Metropolitan Development Commission Regional Center Hearing Examiner Meeting Agenda

STAFF REPORT

Case Number	2022-REG-079
Address (approx.)	1231 Brooks Street
Location	Center Township, Council District # 11
Petitioner	Catalina Realities LLC, by Vijay Reddy
Zoning	D-8 (RC)
Request	Regional Center Approval to provide for demolition of the existing structure and for the construction of a single-family dwelling and a detached garage.

Case Number	2023-REG-001
Address (approx.)	1720 – 1744 North Illinois Street
Location	Center Township, Council District # 11
Petitioner	Arrow Street Development LLC, by Peter D. Cleveland
Zoning	MU-1 (RC)
Request	Regional Center Approval to provide for updated plans for a mixed-use development, previously approved through 2022-REG-006, consisting of an seven-story structure with approximately 273 units, 10,349 square feet of office space and 1,434 square feet of retail, two levels of structured parking, with 159 spaces, an open-air courtyard, and an outdoor game court.

Site plan

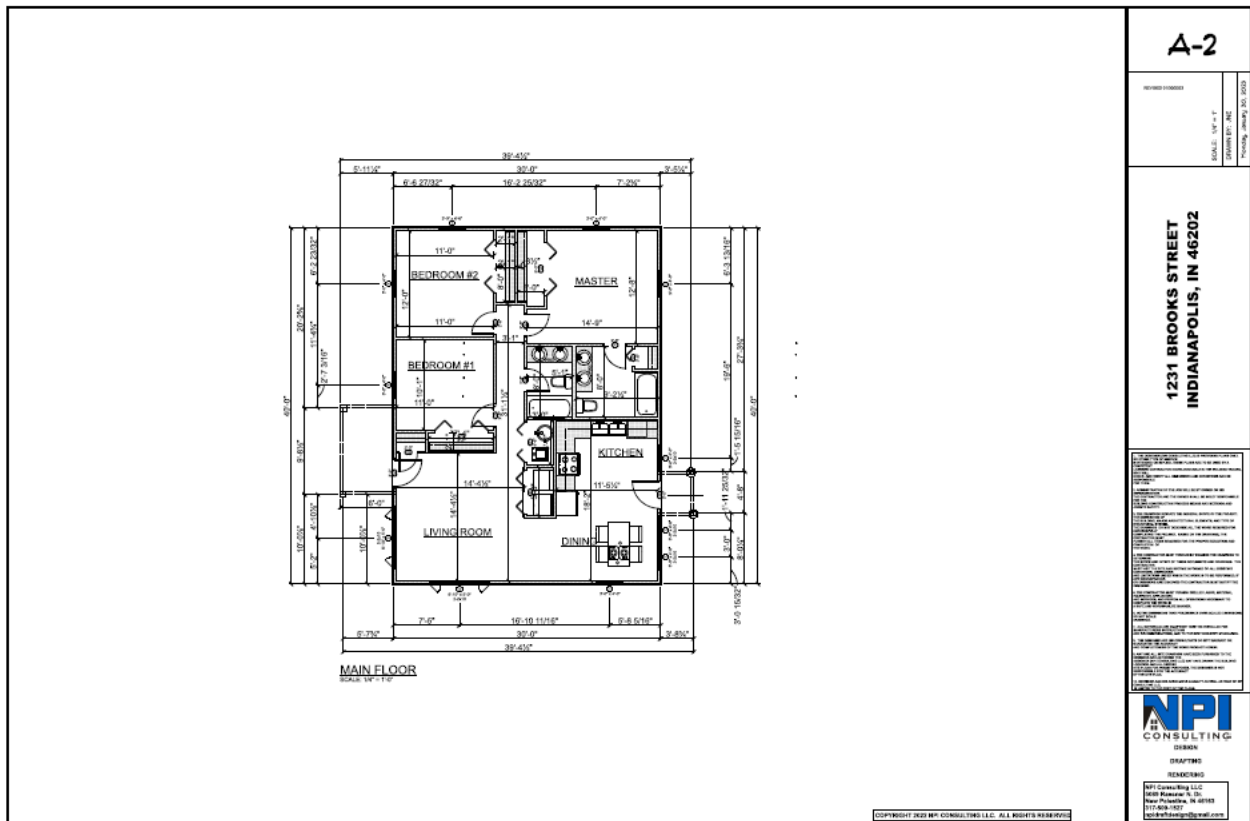
The proposed north and east side yard setbacks would be four feet, according to the site plan. If approved, the D-8 zone would require a minimum of five-foot side yard setbacks, so the site plan will be required to be revised to meet the Ordinance standards.

5. The proposed site plan and elevations would appear to meet the above Guidelines, with setback issues noted above required to be addressed with a revised site plan and details of the building materials needed to complete the review. Therefore, the site plan and

The site plan and building elevations shall be revised and submitted to staff review and approval, prior to the issuance of an Improvement Location Permit.

House elevations and floor plans

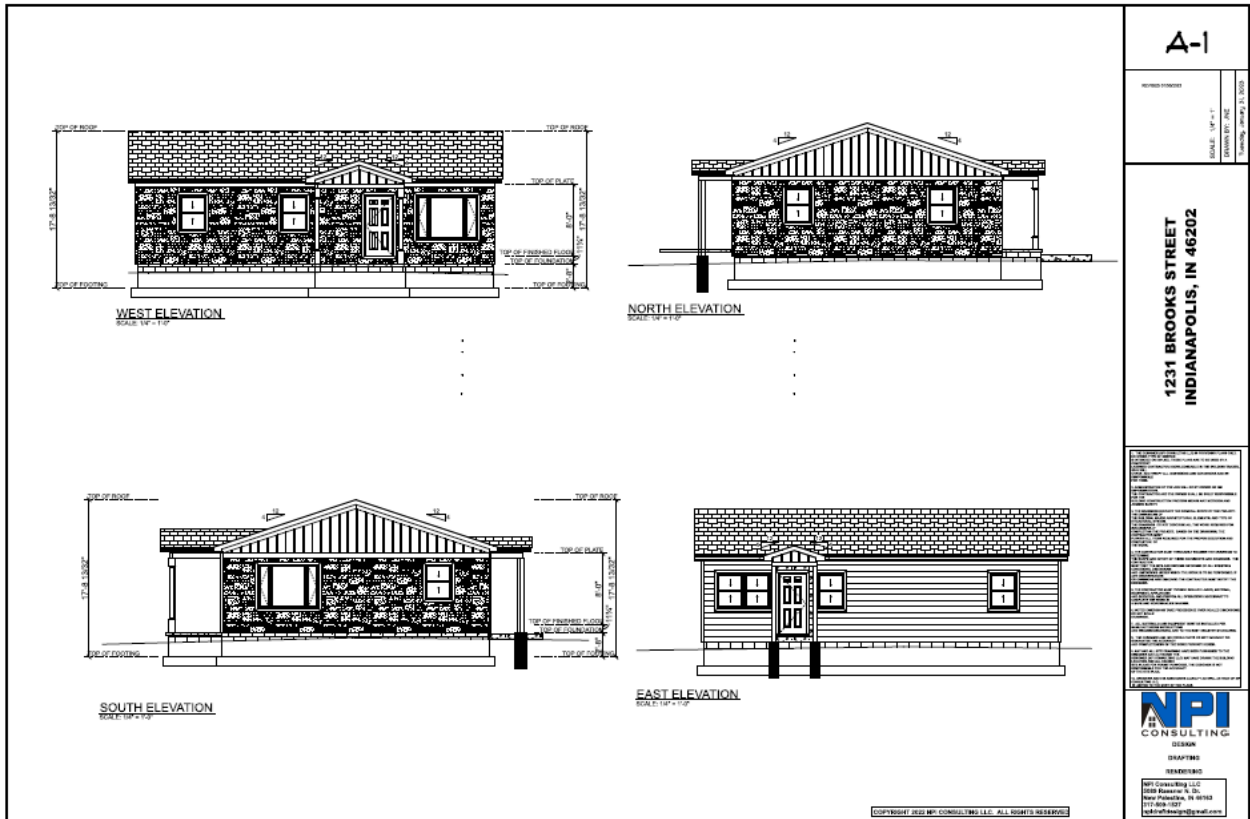
This request would provide for the demolition of the existing house and attached garage and for construction of a new single-family house and detached garage. The petitioner verbally indicated that the home would be owner-occupied. The petitioner and neighborhood group met in January 2023 and revised elevation plans were submitted to the file on February 2, 2023, that reflect the requested changes to the structure. Staff would note that the elevations do not specify the proposed building materials.
